ChiCycle Objection to Planning Application 22/01485/OUTEIA Phase-2 of the West of Chichester Development (Part 3)

ChiCycle object on grounds that the proposed uncontrolled pedestrian and cycle crossing sited between Westgate and the A259 College Roundabout, will have inadequate visibility according to [DFT Traffic Signs Manual \(TSM\)](#) and [LTN1/20](#).

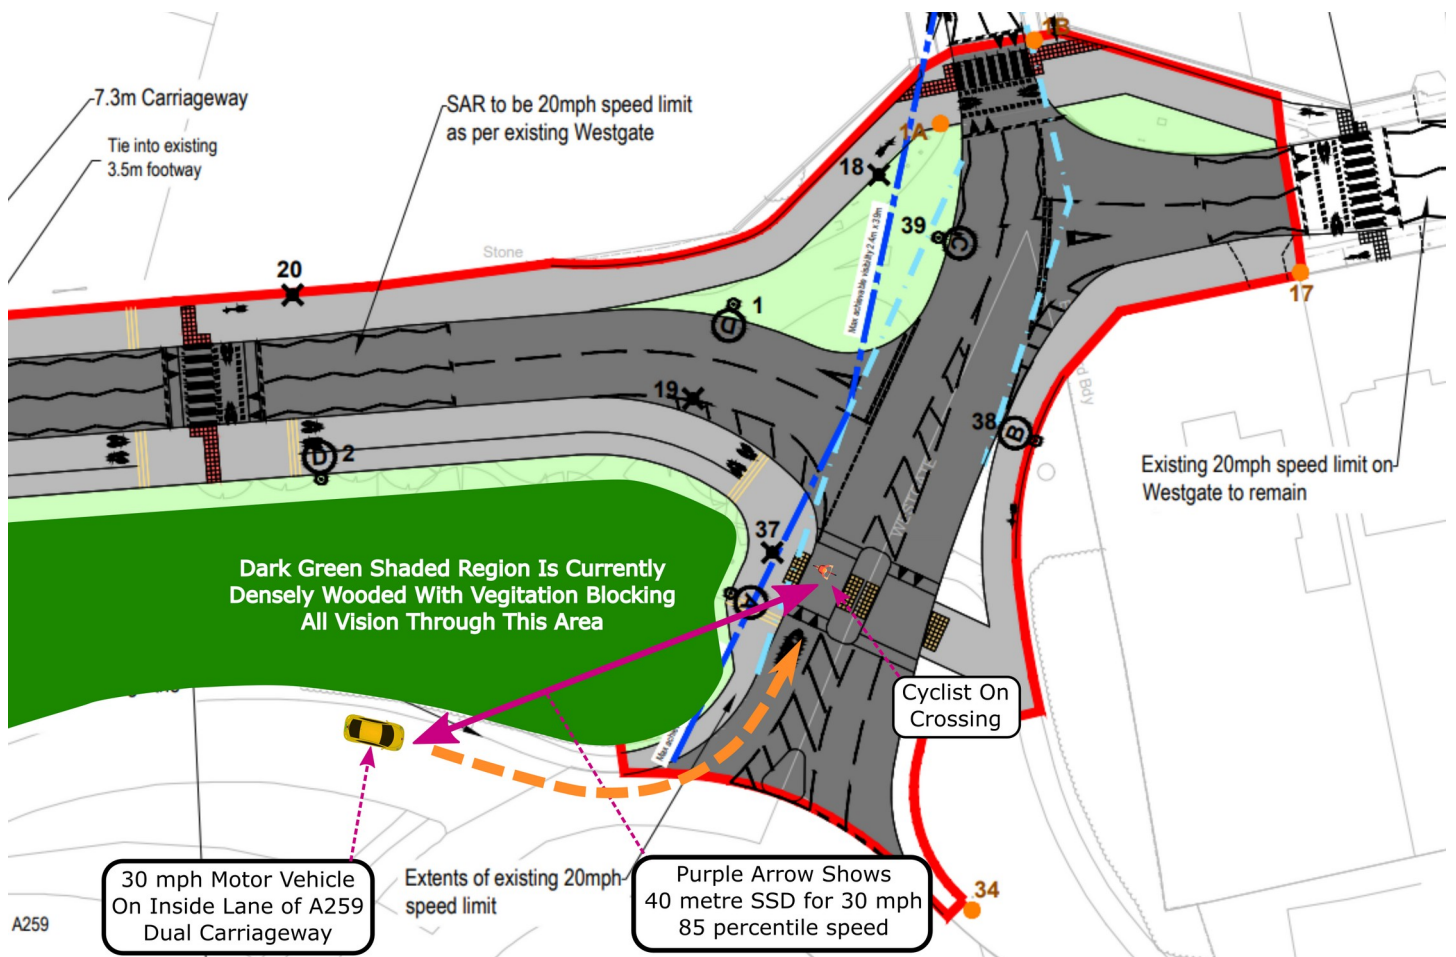
There appear to be no documented traffic speed assessments that relate to the proposed uncontrolled crossing. We note the adjacent roundabout and A259 dual-carriageway are currently national speed limit zones and likely have an 85th percentile average speed exceeding 30 mph. The following pages look at the safety implications of vehicles approaching the uncontrolled crossing with limited visibility from these faster sections of road.

Visibility at the Cycle Crossing is Only 37% of LTN1/20 Minimum 43 Metre Sight Distance

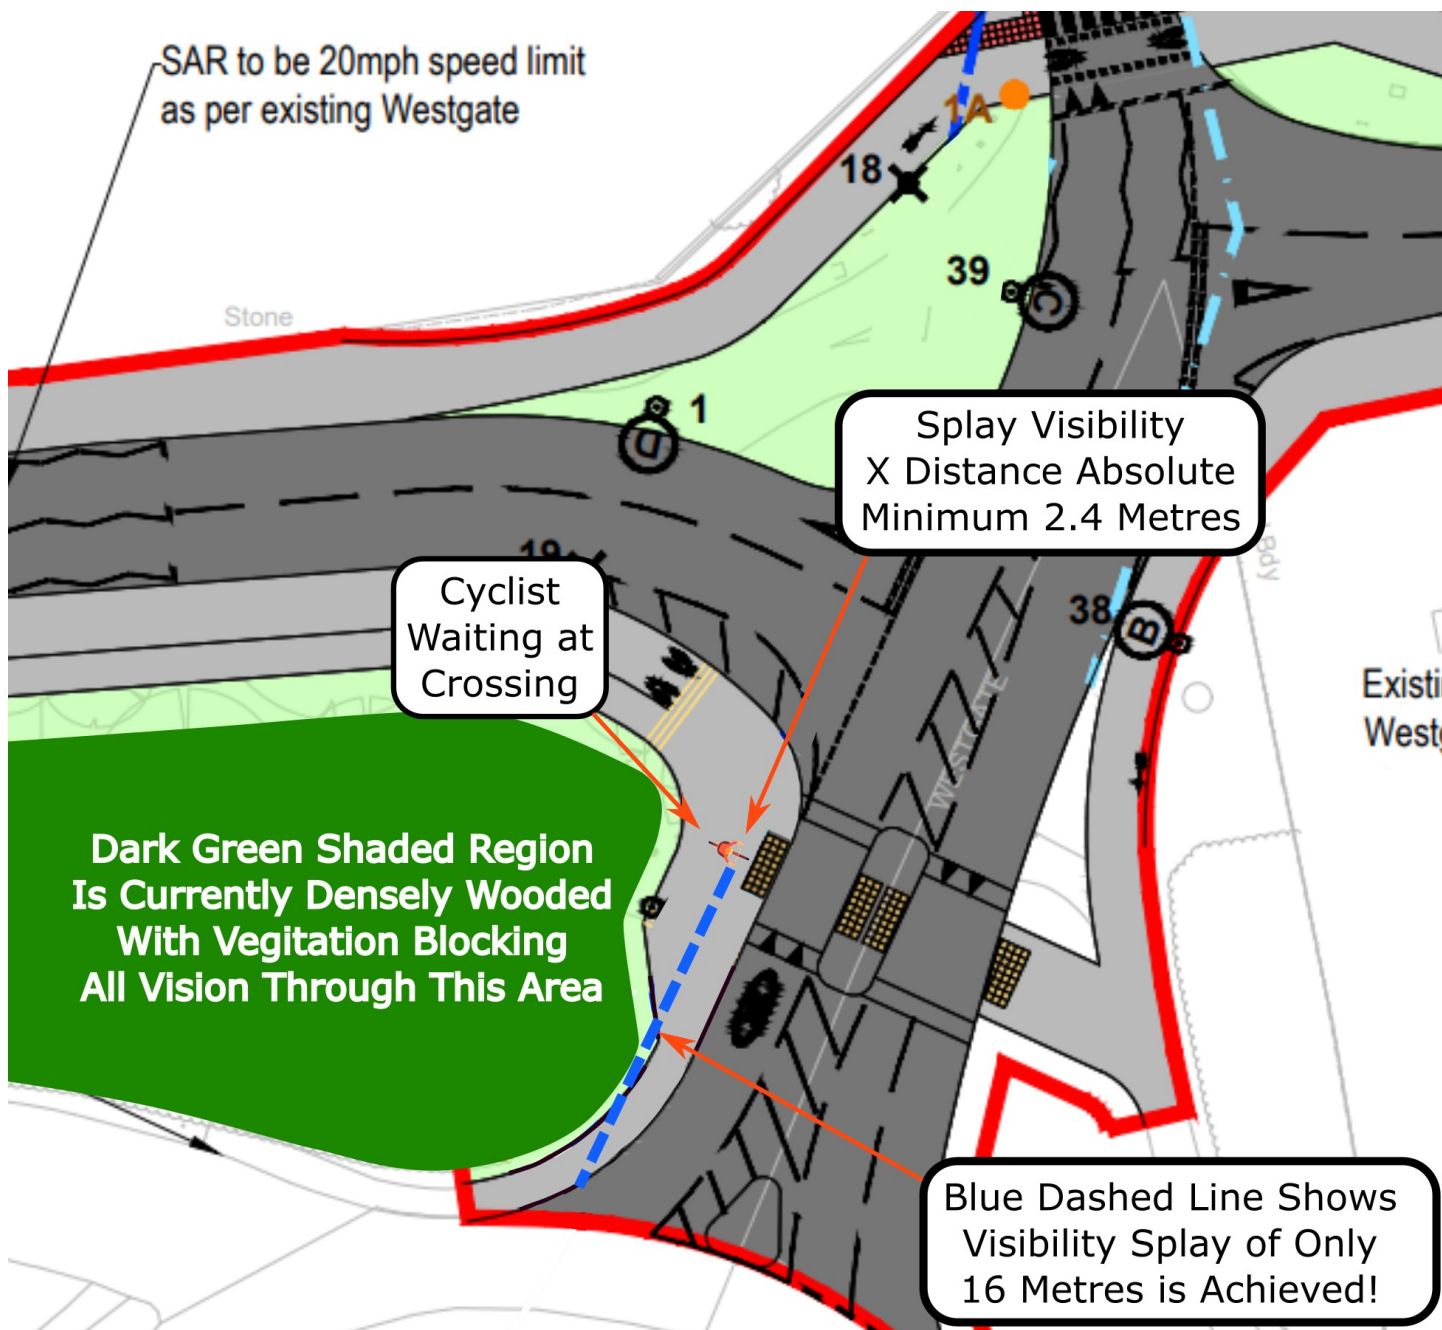
National speed limit restrictions apply to the A259 and College Roundabout adjacent to the proposed crossing. Even if these areas are converted to 30mph speed limits, it is doubtful the Manual for Streets minimum 43 metre splay visibility distance is adequate. Arguably, a better guide for visibility at a crossing on the arm of a busy “A” road roundabout is DMRB volume CD 109 Table 2.10. It advises a desired minimum SSD of 90 metres if this was a 30 mph speed limit roundabout. In either case, a crossing with a clearly inadequate 16 meter visibility splay represents an unacceptable danger to road safety. It is also a significant departure from national standards for safe highway design.
